UNITED STATES
NUCLEAR REGULATORY COMMISSION

No. 40-8902
SUA-1470, Amendment No. 22

TECHNICAL EVALUATION REPORT

FACILITY: Bluewater Mill

FIGURE 2-1
MAIN TAILINGS PILE
TYPICAL SECTION

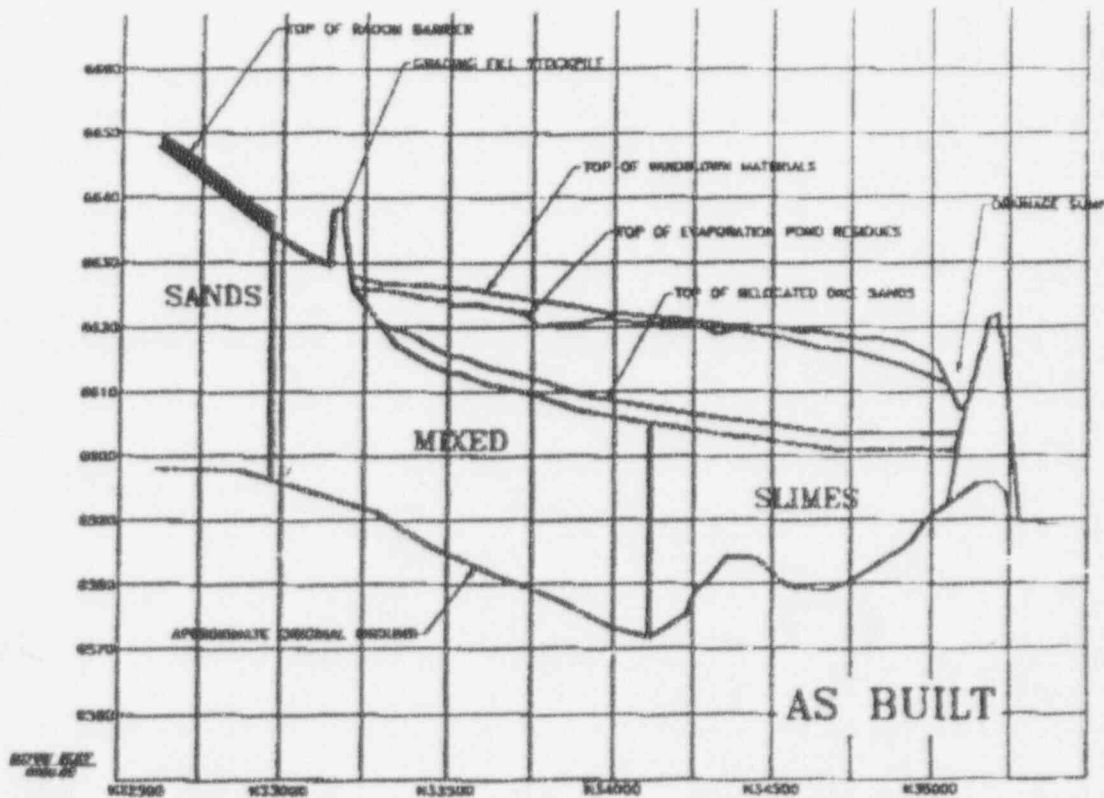
ARCO's model for the Slimes Area does not appear to represent the various off-pile material layers correctly. NRC staff noted that ARCO's October 30, 1992, report indicated that 623,000 cubic yards of windblown material were placed on the Slimes Area of the main tailings pile and constitute a layer 3.2 feet thick over an area of 120 acres. The reclamation plan states there is approximately 1.4 million cubic yards of evaporation pond material. The cross-section of the as-built pile (see Attachment 2) in the 1993 final design report, indicates this material is about 8 feet thick over the Slimes Area while the windblown material is 1 to 4 feet thick. Therefore, over 4 feet of evaporation pond material must be in the upper 8 feet of contaminated material, but it was modelled only in the 8 to 10-foot-deep layer.

ARCO stated in the letter of March 10, 1994, that the evaporation pond sludge mixed with clean borrow and berm soil was placed on the pile between January 1991 and May 1992. Windblown material was placed between April and August of 1992. This supports the as-built cross-section of the pile indicating the sequence of the various off-pile materials on the Slimes and Mixed Areas (see Attachment 2). However, the appropriate Ra-226 value to use for the 4-8-foot interval in the Slimes Area is still in question. Since uncontaminated soil was mixed with the evaporation pond sludges to reduce the moisture content so that the material could be moved to the main pile, the 1000-year Ra-226 value would be lower than that used in the 1990 reclamation plan, but higher than the Ra-226 concentration used in the 1993 final design because of the high Th-230 (which decays to Ra-226) content of the evaporation pond sludges.
